Subject: Consent Decree Action 80-73699

TITLE:	RIVERVIEW SITE PROPOSED REPAIR OF DRAINAGE SYSTEM EXIST. & PROPOSED REPAIR SECTIONS
LOCATION:	RIVERVIEW, MI SK-1R-1

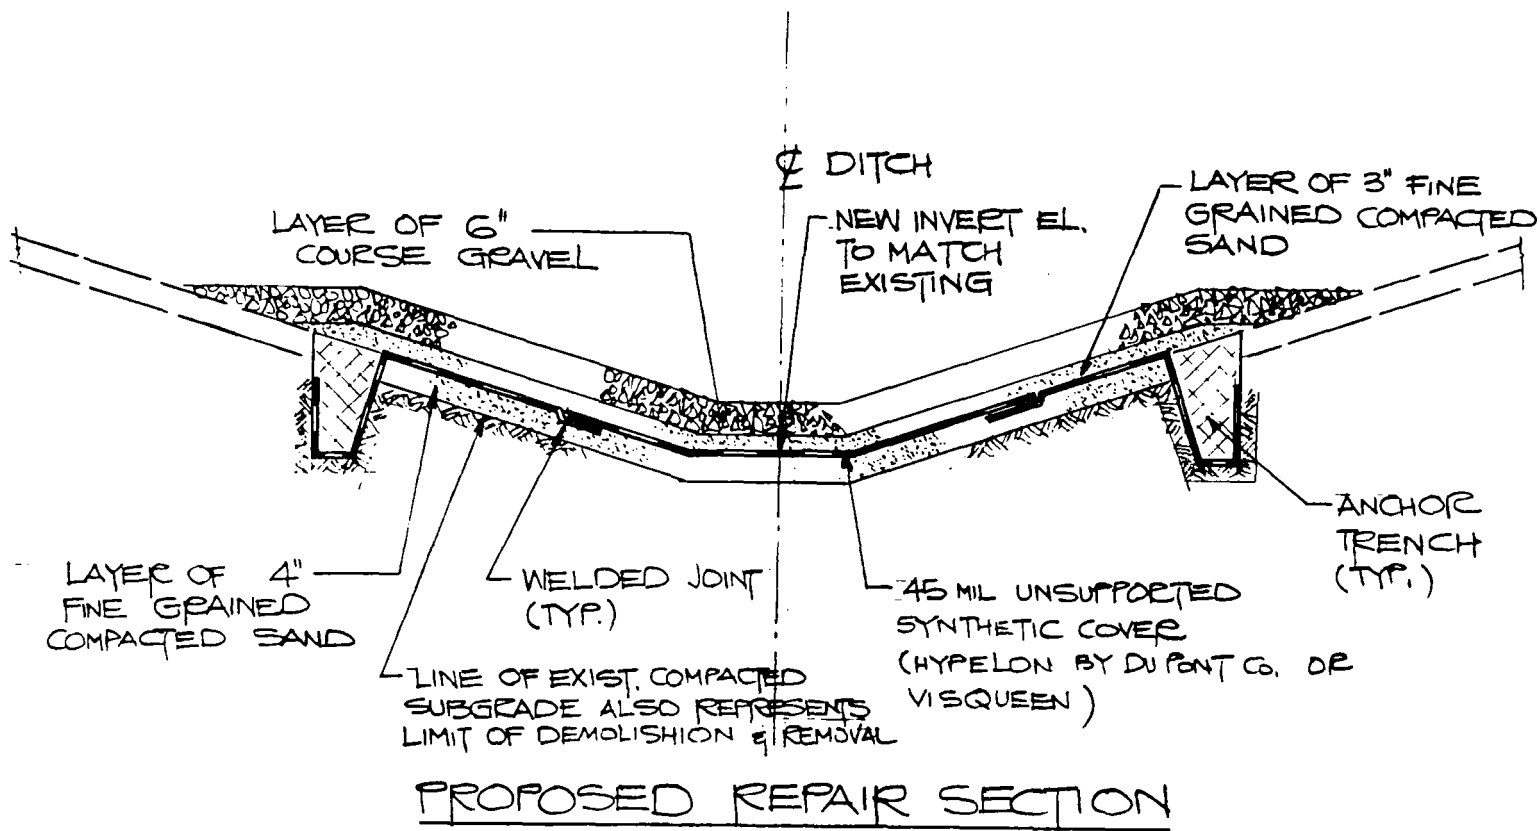
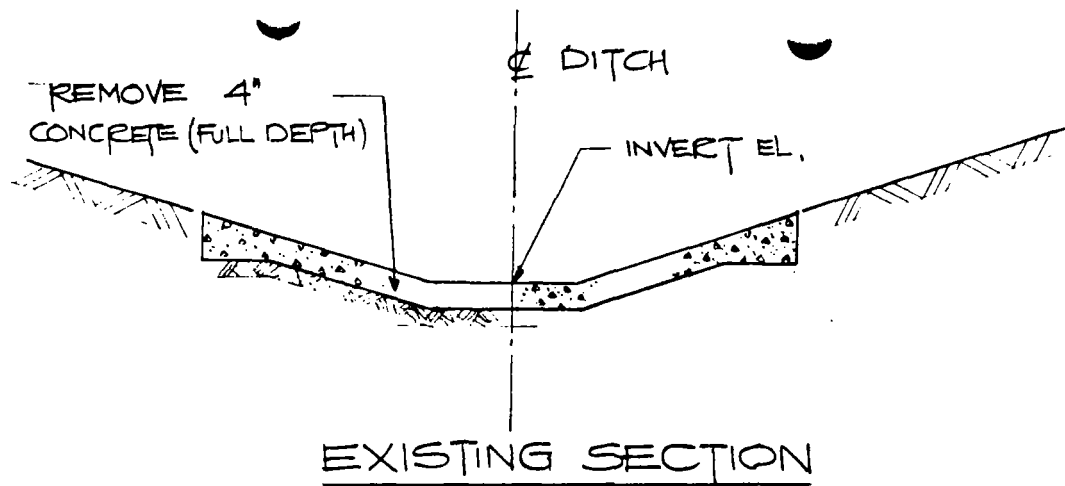
I have previously advised you of many attempts to repair the joints and seams in the existing concrete drainage way bisecting the site shown in Exhibit D of the Consent Decree.

BASF has determined that further attempts to seal the joints and seams is impractical. Therefore, we propose to remove most of the concrete (from the start to the fence) and replace it with a heavy synthetic liner installed as depicted in the attached sketch.
